CITY OF BLOOMINGTON
PLAT COMMITTEE
December 9, 2024 at 4:00 p.m.

BLOOMINGTON PLAN COMMISSION
STAFF REPORT – Second Hearing
Location: 1217 N. Madison Street

CASE #: DP-37-24 / PLAT2024-09-0038
DATE: December 9, 2024

REQUEST: The petitioner is requesting primary plat approval for a 2-lot subdivision of 0.27 acres in the Residential Small Lot (R3) zoning district. Also requested is delegation of secondary plat approval to staff.

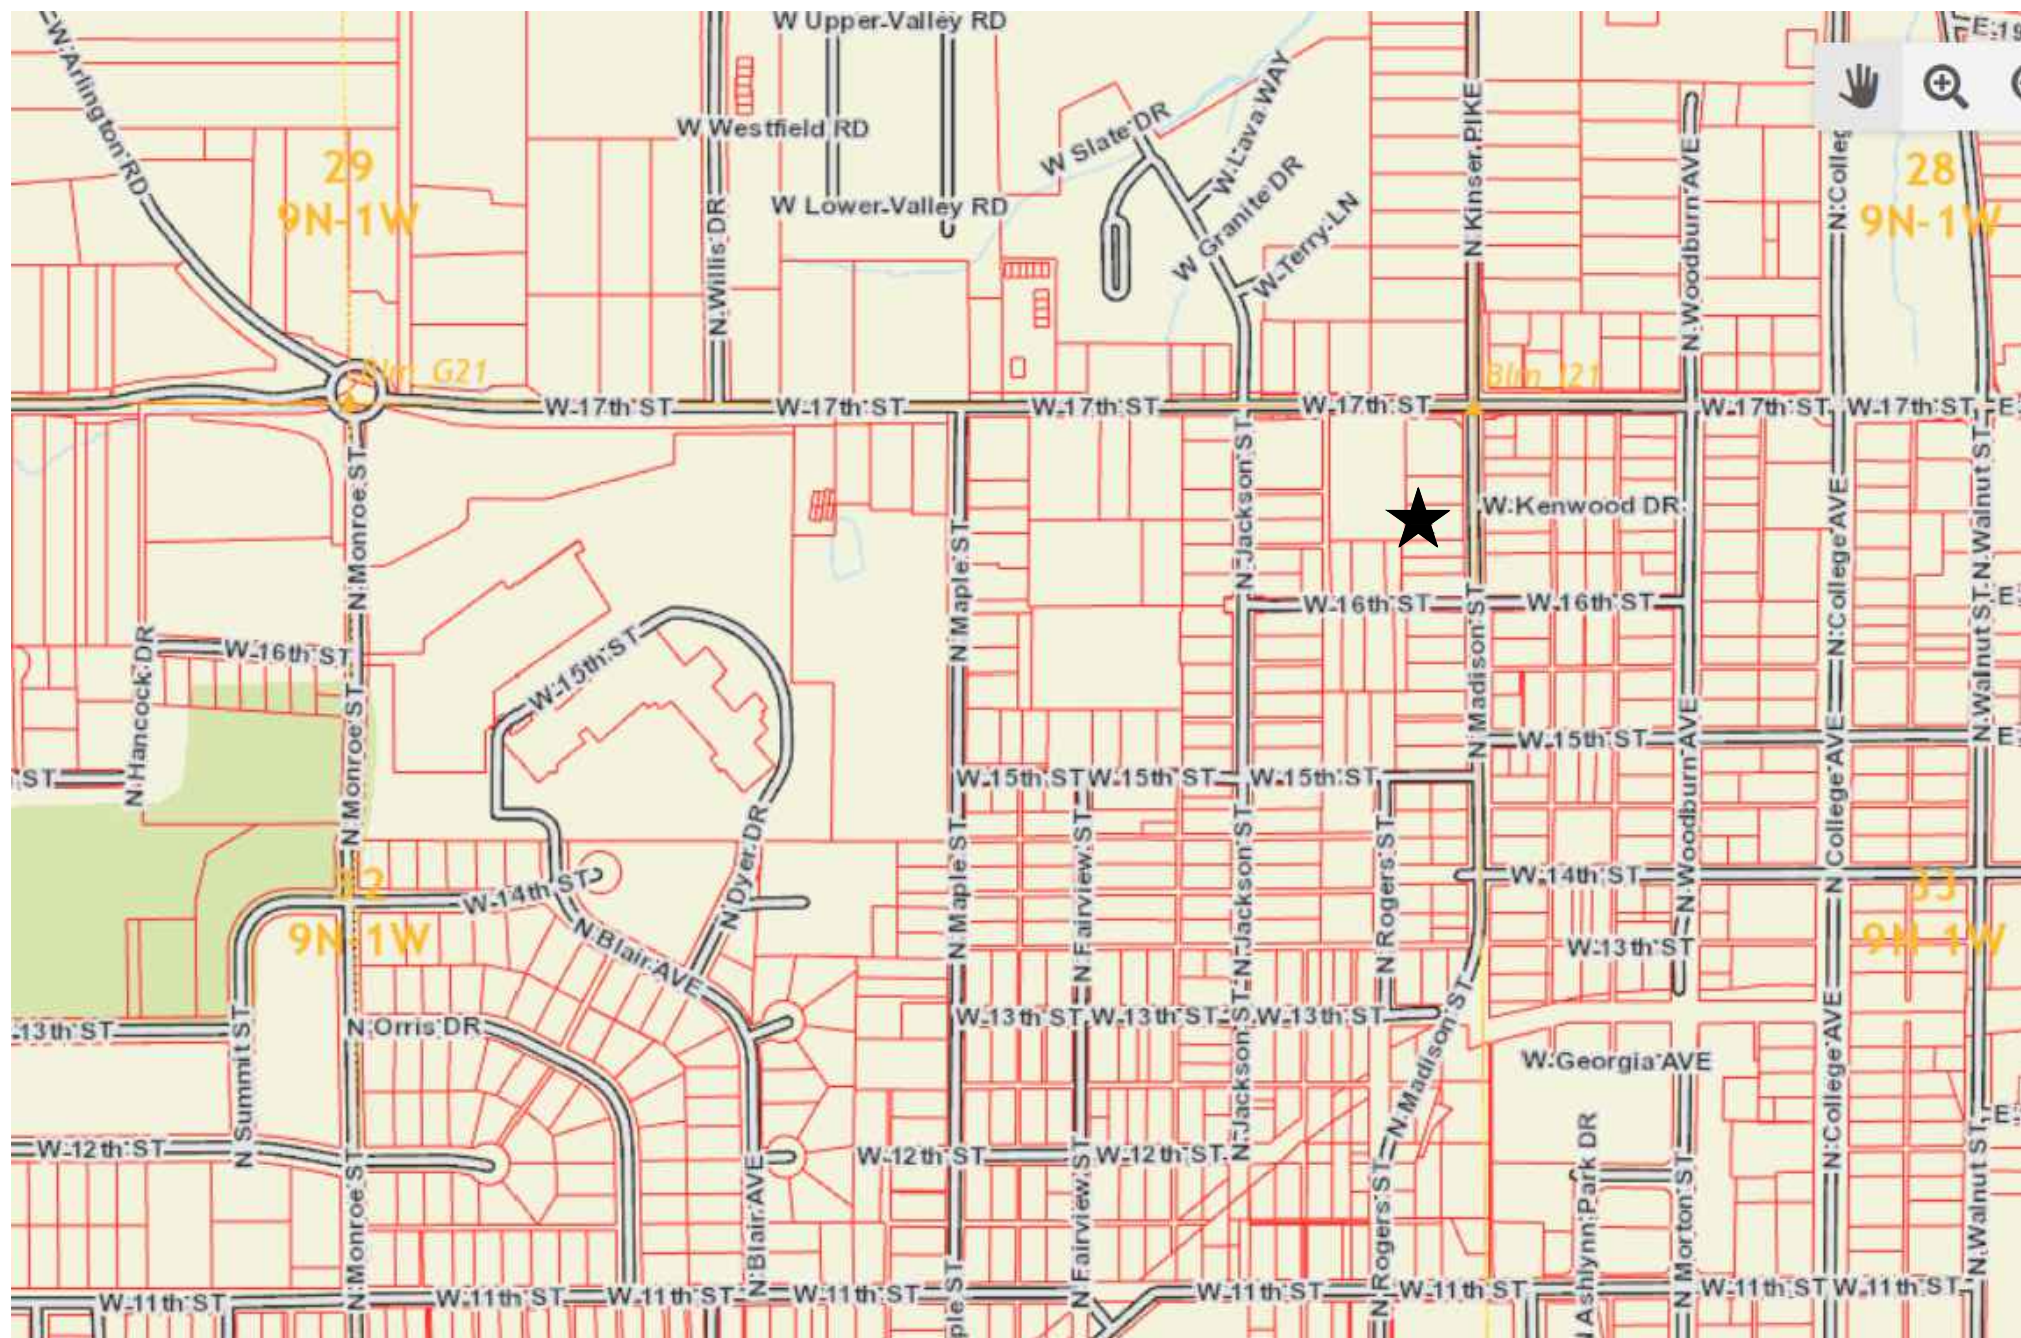
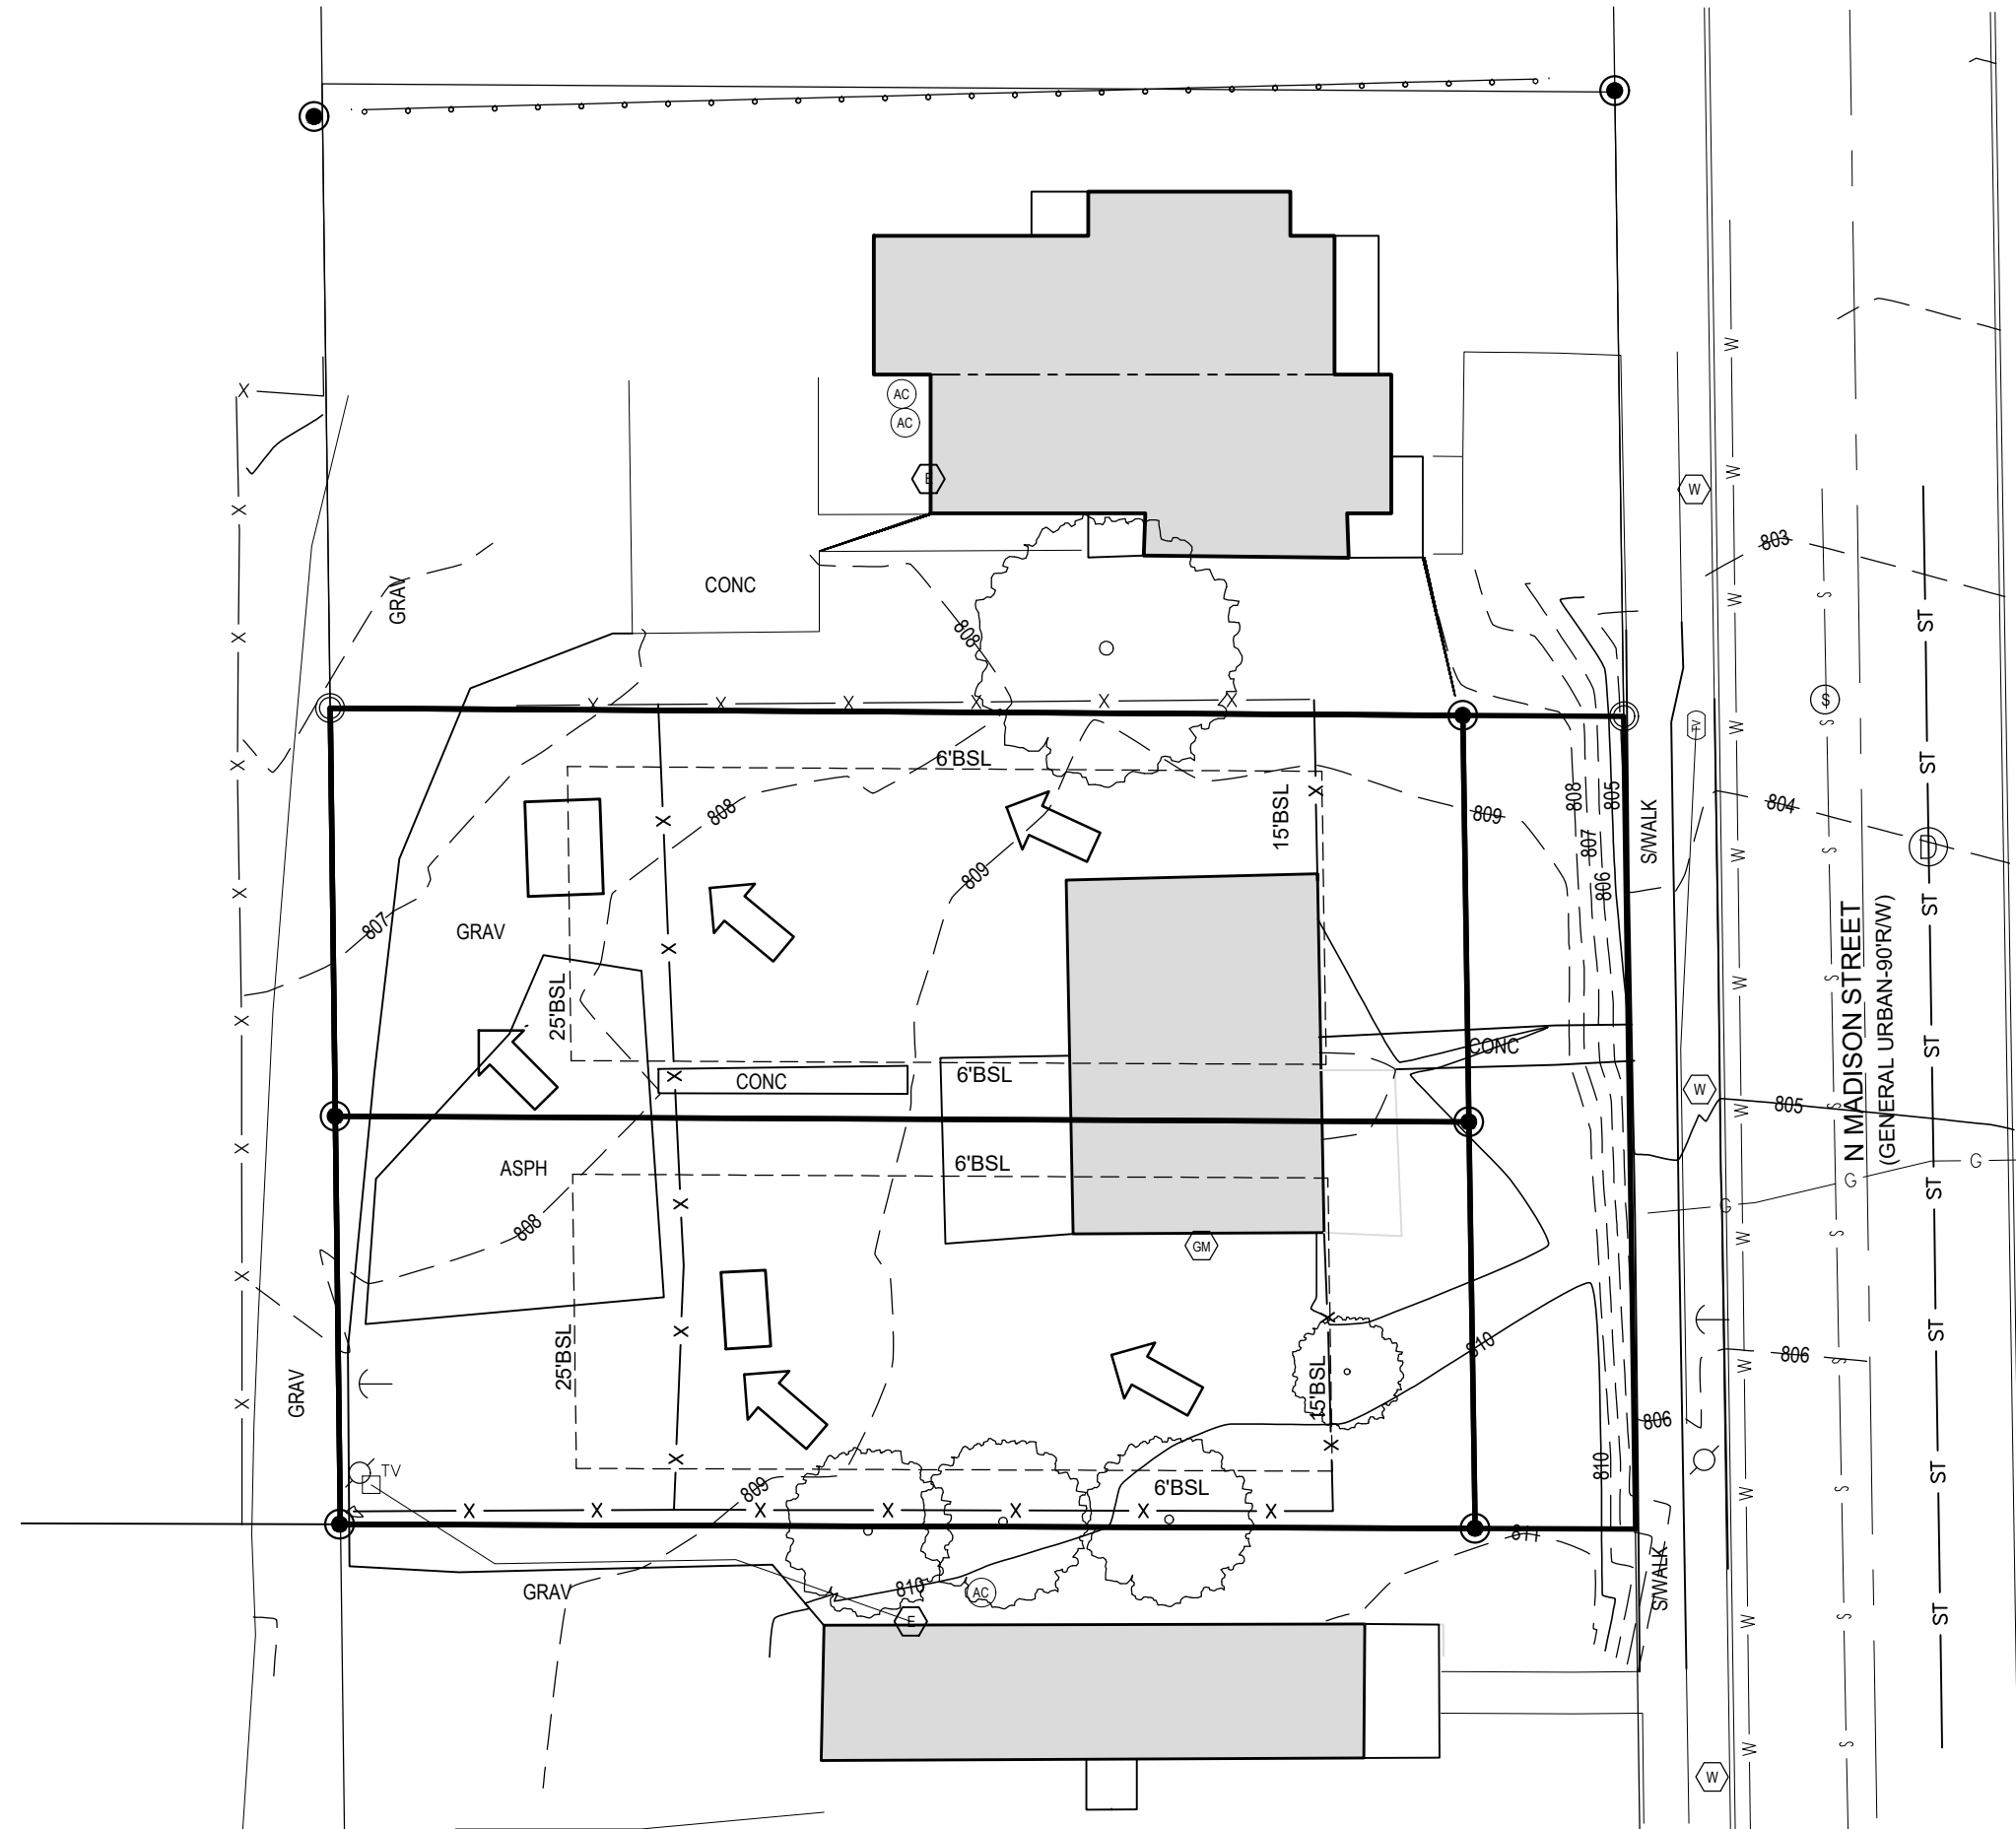
Transportation facilities: Madison Street is classified as a General Urban typology and requires a 10' wide concrete sidewalk and 8' tree plot. A total of 84' of right-of-way is required based on the Transportation Plan. The Planning and Transportation Director has approved the preservation of the existing sidewalk and tree plot. There are existing street trees in the tree plot, however one additional tree is required along this frontage to meet UDO requirements are met. A condition of approval has been included to that effect.

Tree plot width: The minimum tree plot width required for the General Urban typology is 8' and the petitioner is proposing to maintain the existing 5' wide tree plot. The City recently installed street trees along this section of Madison Street and are in good condition. The Planning and Transportation Director has approved the preservation of the existing sidewalk and tree plot due to the adjacent slope challenges with relocating the sidewalk further into the property. Street trees are required not more than 30' from center and one additional tree is needed to meet the UDO requirements.

Lot area and lot width: The minimum lot width in the R3 district is 50' and the minimum lot area is 5,000 square feet. With the use of the Incentives allowed within the UDO to allow a reduced lot width from the required 50' to 42.97', all of the proposed lots meet the UDO standards.

ROW width: Madison Street should have a total of 84' of right-of-way. The petitioner will be dedicating approximately 15' of right-of-way along this frontage to meet the total 42' of right-of-way required from centerline.

1. Individual drainage plans will be submitted to CBU for approval with the building permits for each lot.
2. Each lot must be constructed to the either the Sustainable Development or Affordable Housing Incentives through a Zoning Commitment.
3. Street trees are required not more than 30' from center along the entire property frontage.
4. All easements on the plat must be defined per UDO requirements.
5. Secondary plat approval is delegated to staff level.
